**Response to Highways England Deadline 9 Documents 2.6(a), 2.8(a), 3.1(c), 4.1(a), 4.3(a), 8.94 & 8.98:**

**2.6(a) Traffic Regulation Measures Plans Part 2 Speed Limits**

**2.8(a) Engineering Drawings and Sections**

**3.1(c) 4th Draft Development Consent Order**

**Traffic Regulation Measures Regulations 5(2)(o) Speed Limits Sheet 2 of 7**

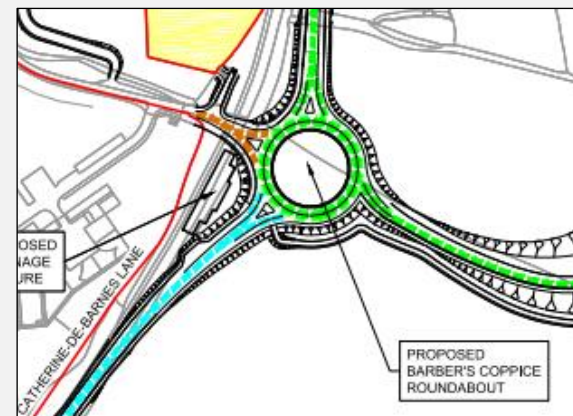
**30mph Speed Limit on Access Road off Proposed 'Barber's Coppice Roundabout'**

The unclassified road off Barber's Coppice Roundabout is an access road to my property, Birmingham Dog's Home and Woodhouse Farm. The road currently has a speed limit of 10mph.

To reduce the risk of anti-social behaviour due to drivers rapidly accelerating on exiting Birmingham Dog's Home the speed limit of this access road should remain at 10mph and not increased to 30mph as shown on the drawing opposite.

I would be grateful if the speed limit was proposed to remain at 10mph on this access road.

**Drainage Engineering Drawings Regulations 5(2)(o) Sheet 2 of 7**

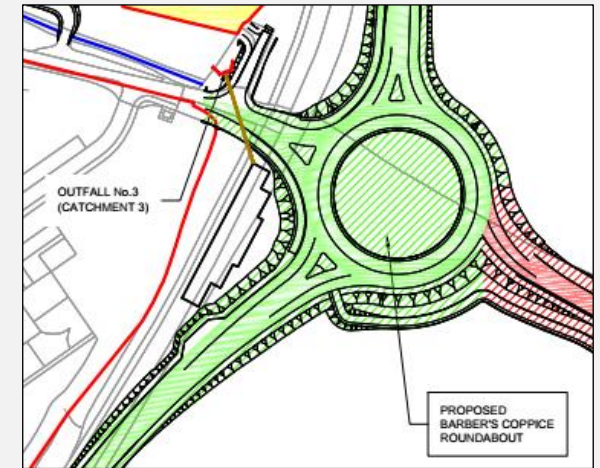
**Outfall No.3 (Catchment 3)**

The proposed location of Outfall No.3 (Catchment 3) is shown on land that reverts to my ownership as a consequence of the Scheme and will therefore require rights of way are provided for maintenance.

It can easily be moved to a location that falls outside my new boundary and I understood that this had previously been agreed with Highways England.

I would be grateful if this outfall was moved to a new location outside my boundary.

**Work No. 54 – as shown on Sheet Nos. 2 and 3 of the works plans and being the construction of -  
(a) Private Means of Access to the property known as Four Winds and any associated tie in Works;**

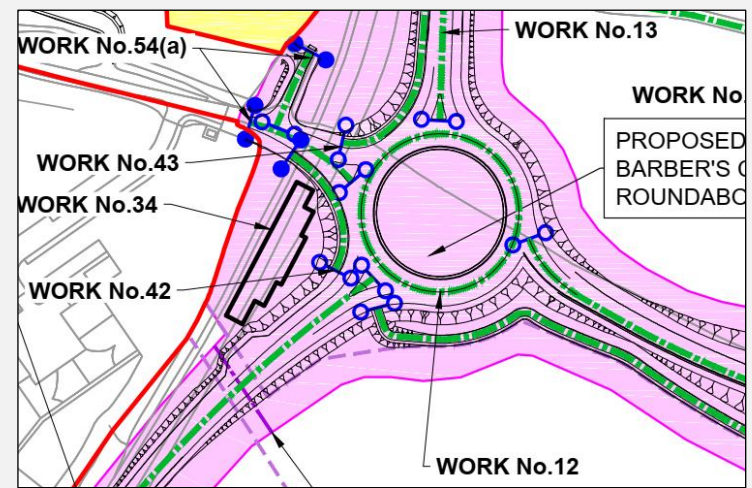
**POR Comments:**  
 A new rear access is being provided to my property and sheet 2 of HE document 'TR010027-000873-TR010027\_M42J6\_2.3(a)\_Work\_Plans' indicates that work 54(a) relates to that.  
 It is assumed from discussions with Highways England that 'tie in works' will include new fencing to my boundary, new access gate, landscaping and planting but no detail has been provided.  
 Works are also required to my front entrance, which will include a new driveway, new fencing to my boundary, landscaping and planting, but these have not been included under work 54(a) or as a separate works item. Again, no detail has been provided.

**PART 7: ALTERATIONS TO PRIVATE MEANS OF ACCESS**

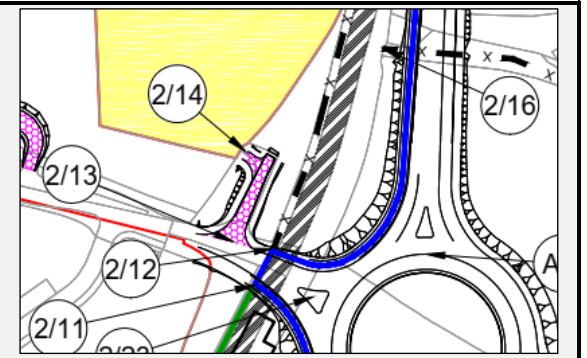
As access to my property is being provided directly off Catherine de Barnes Lane, rather than access being via an access lane off an access lane, as shown on the original DCO application, Part 5 (above) of HE document 'TR010027-000855-TR010027\_M42J6\_3.1(c)\_Development\_Consent\_Order\_Tracked' confirms that these works have been removed from the DCO.

However, as a new rear access is being provided to my property one would expect this to be shown in Part 5 as it is a substitute for the stopped up private means of access. Instead it has been moved to Part 7 and is shown as being stopped up.

As the front access is being altered, one would expect this to be shown in Part 7 (above) of that document. Instead, Part 7 includes alterations to my front (3/58) and rear (2/13) access and indicates that both the front and the rear access points are to be stopped up.

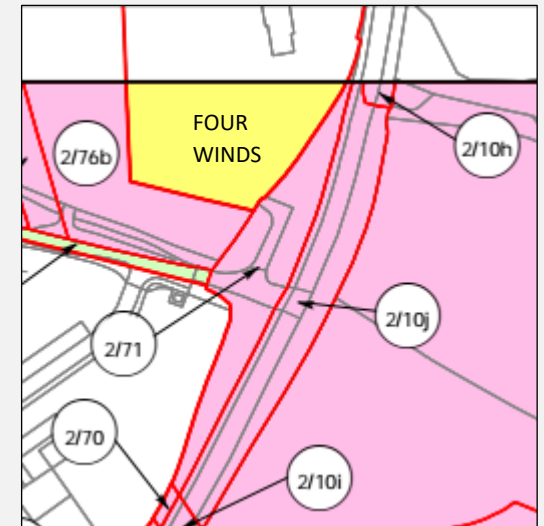
- HE have confirmed that we own the subsoil rights to plots 2/71 and 3/3a, but we believe we also own the subsoil rights to plot 2/10h and plot 2/10j which runs in front of my property as shown on the drawing opposite:
- Plot 2/76b includes a strip of land around my boundary which we have occupied and exclusively used for 20+ years and indeed the area is fully enclosed by the fencing we erected. HE have been made aware of the facts but this has not been included in any of their documentation.
- Also note, the road in front of my property before the construction of Catherine de Barnes Lane was Bickenhill Lane, which was then stopped up. Land should then have reverted to my ownership under the Ad Medium Filum rule rather than ownership being classed as Unregistered / Unknown.
